Planning and Zoning Commission

Tuesday, October 4, 2022

Agenda Title: Discuss and consider action on Architectural Pre-Approval for the Glenn and Venue buildings of the Backyard project located at 13801 Bee Cave Parkway, Bee Cave, TX 78738

Subject: **Backyard – Glenn and Venue Architectural Pre-Approval** - *COBC Staff comments round 3 (final)*

G5

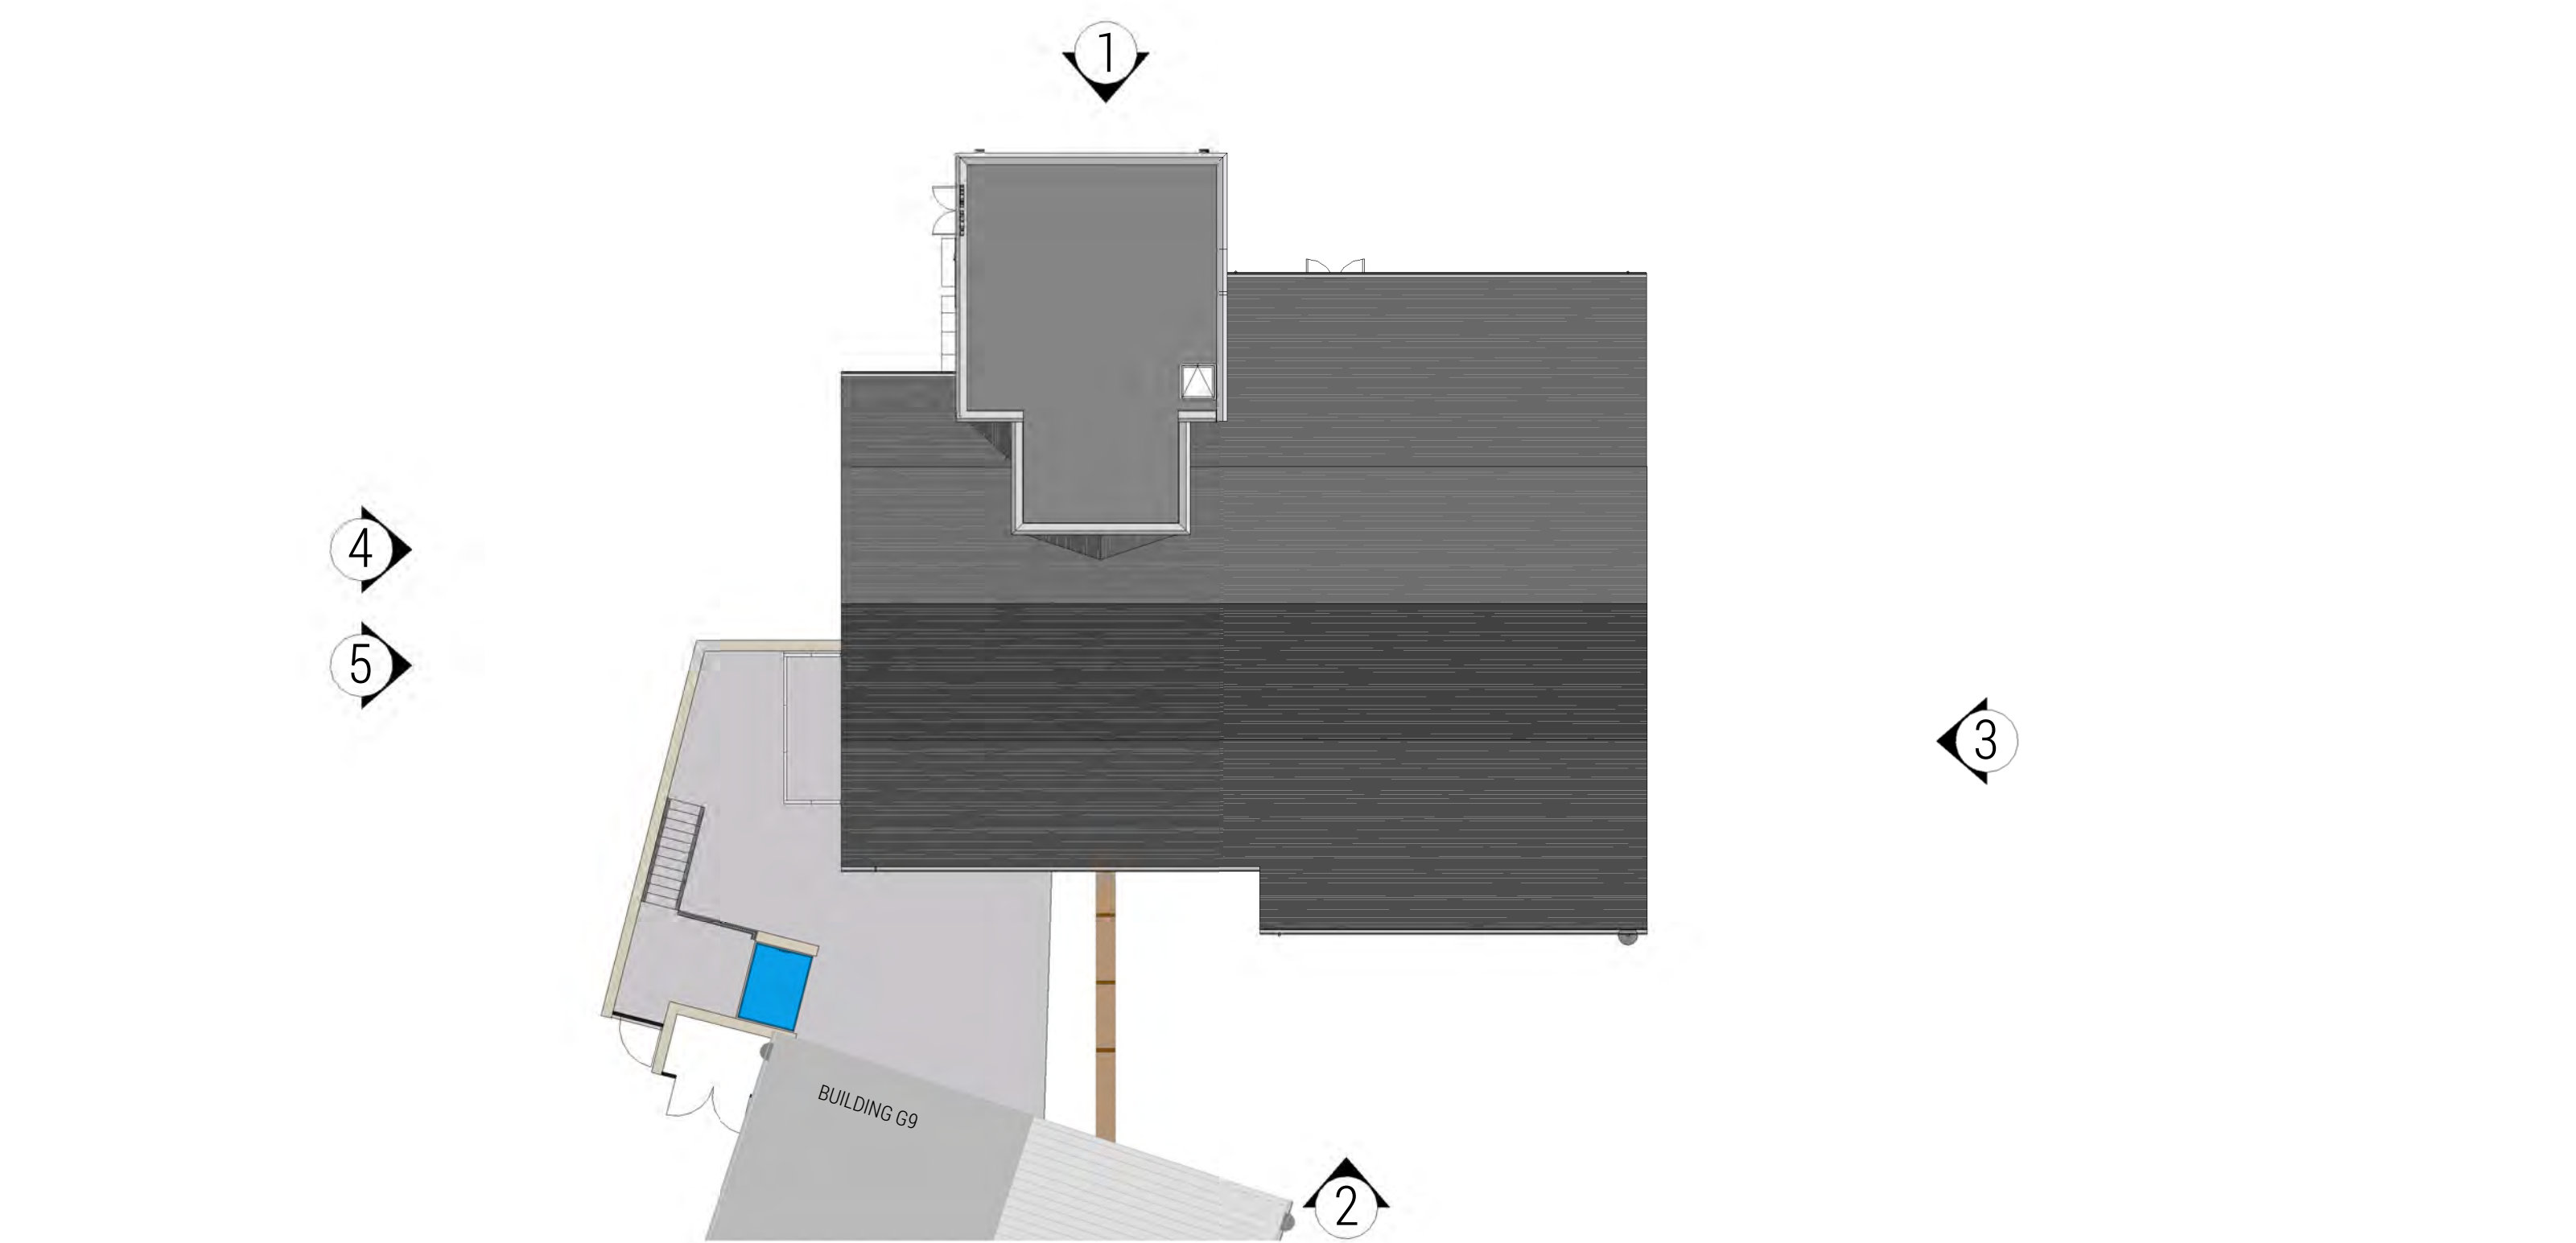
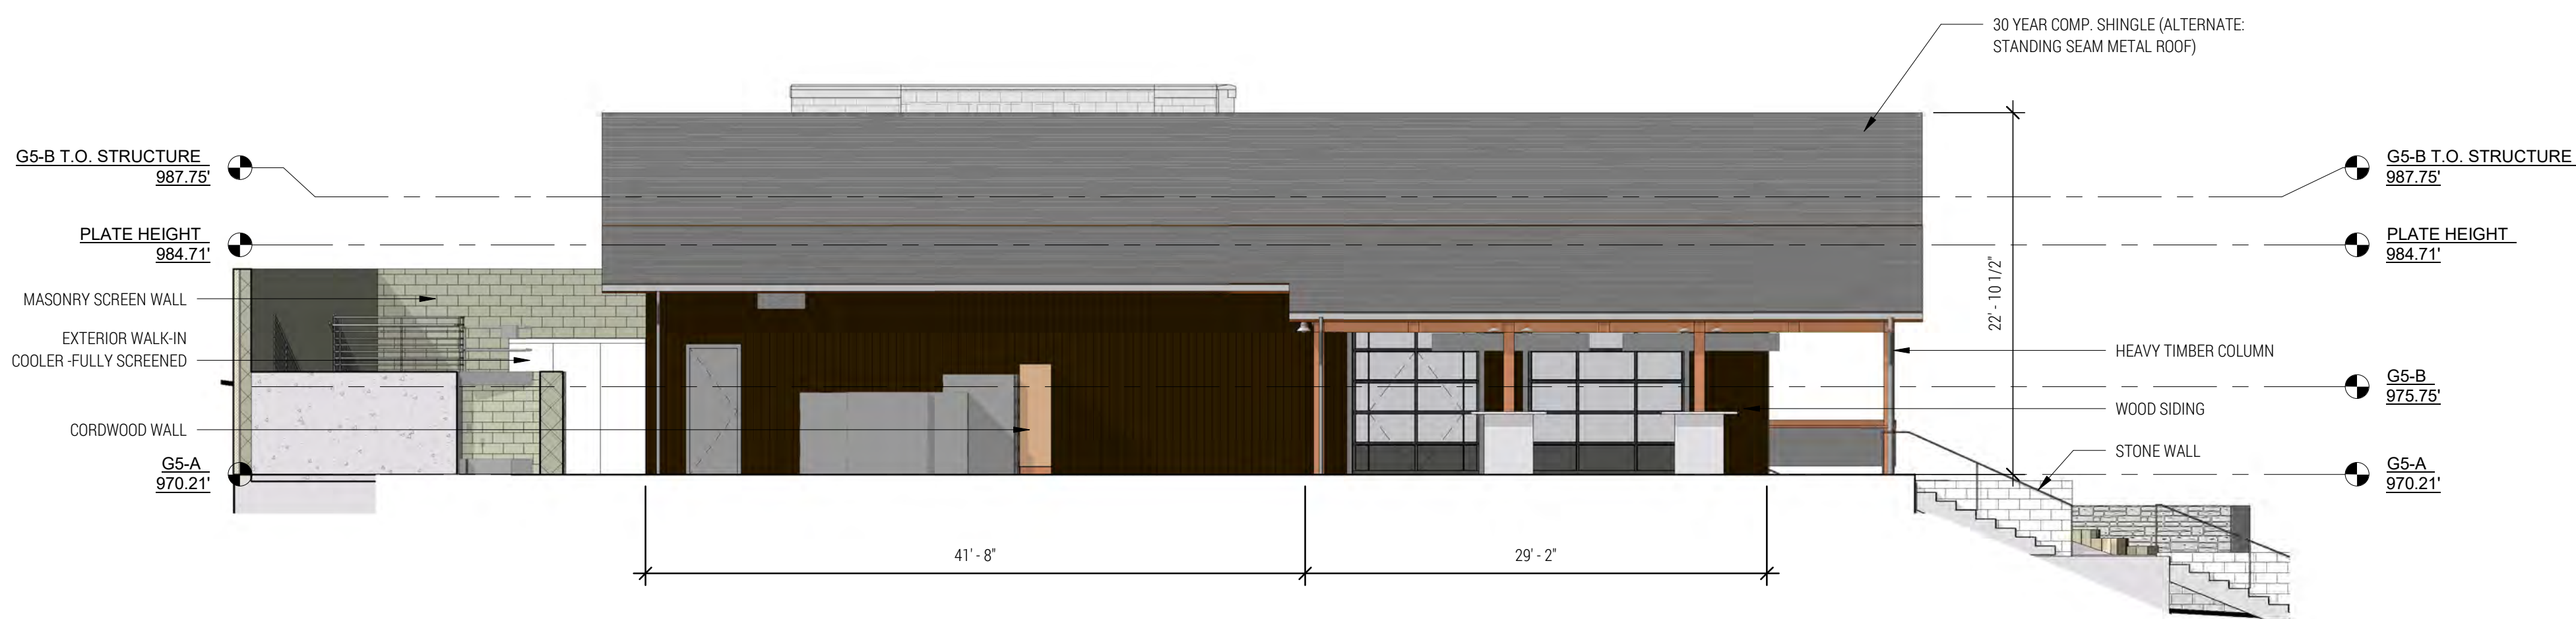
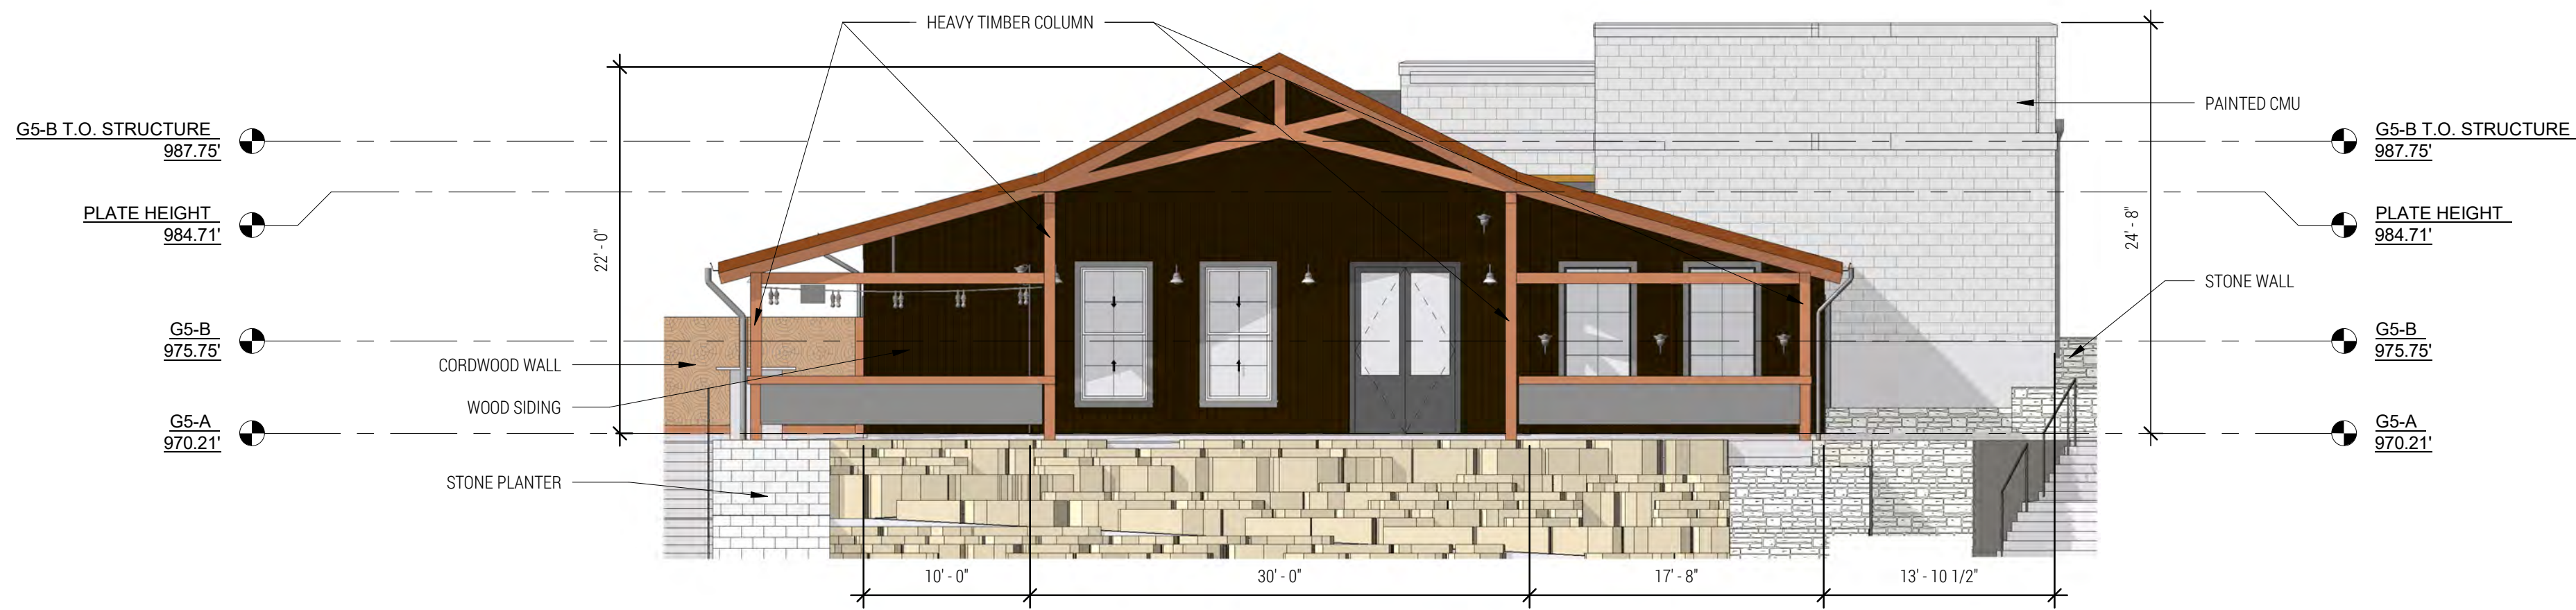
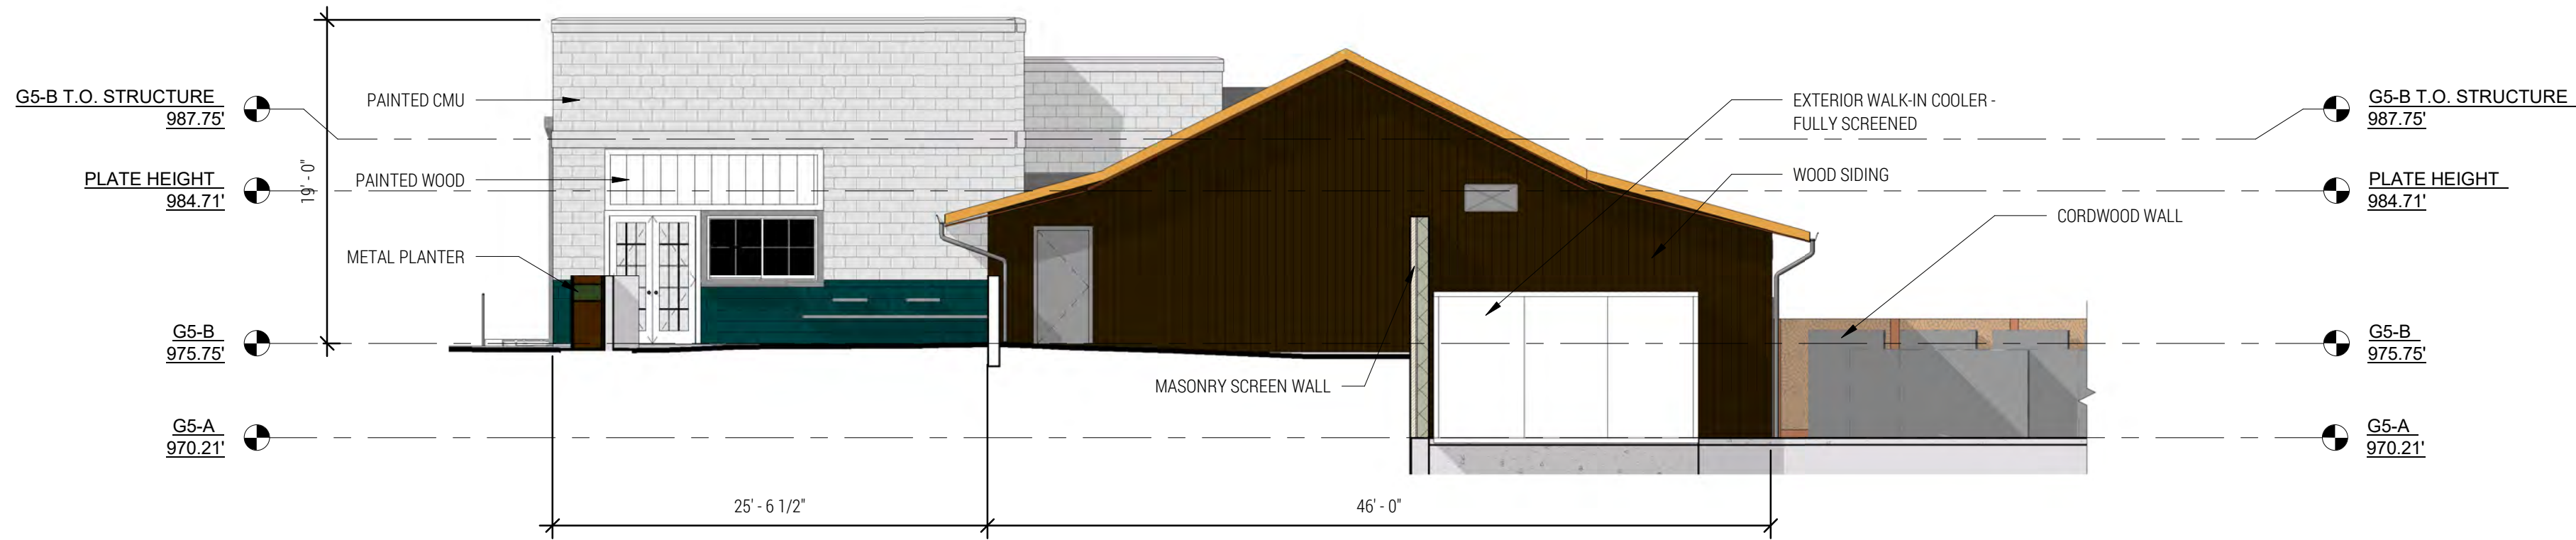
Gross Area (SF) Allowed	Gross Area (SF) Actual	Bldg. Footprint (SF) Allowed	Bldg. Footprint (SF) Actual	# Levels	Building Height (from low grade) allowed	Building Height (from low grade) actual	Venue 17' lower than finished grade of Willie Way	Retaining wall at rear of stage min. 4' above finished grade of Willie Way	Retaining wall at rear of stage landscaped on Willie Way side and finished with stone	Venue architecture complies with PDD Ex. D	If Venue architecture deviates from PDD Ex. D it complies with City Standards**	Notes / Other Comments	DESIGN TEAM COMMENTS	Notes / Other Comments
									Ex. C - III.A.3	Ex. C - III.A.3	Ex. C - III.A.3	Ex. C - III.A.5	Ex. C - III.A.6	COBC 8.30.22	DATE	COBC 9.22.22
Venue	Live Oak Amphitheater	96,000*	85,475	54,000	49,813	2	55'-0"	50'-0"	Generally. The Venue FFE is confirmed at 960'. The grade of Willie Way behind the venue (West/Elevat ion No. 2) is varies from 977' to 974'. Venue is 14' to 17' below Willie Way.	Yes. The grade of Willie Way behind the Venue (West Elevation No. 2) varies form 977' to 974'. The top of the retaining wall generally follows the grade of Willie Way and there is an 8' extension of the wall for its entire length. The extension made of 2'x4' limestone blocks was approved with the Subdivision Construction Plans. The top of the retaining wall and top of the 8' extension are depicted in the West Elevation.	Yes. Wall and landscaping are detailed in submitted Subdivision Construction Plans.	Yes. TPO membrane roofing is not visible from a public way.	N/A. Architecture is consistent with Ex. D.	1. Materials Legend: there are a number of materials crossed off, please clarify. 2. Materials Call Out Updates: North Elevation 3A - The callout for 19 seems incorrect, please review. There is a callout for 9, please update to 9A or 9B as applicable. West Elevation 2A - There is a callout for 15 but that material painted steel panels/trellis) has been crossed out on the legend. Please update. South Elevation 1A - The callouts for 9A appear inconsistent. Please review and update.	KEYNOTE LEGEND HAS BEEN REVISED AND ELEVATIONS UPDATED	Noted. Thank you.
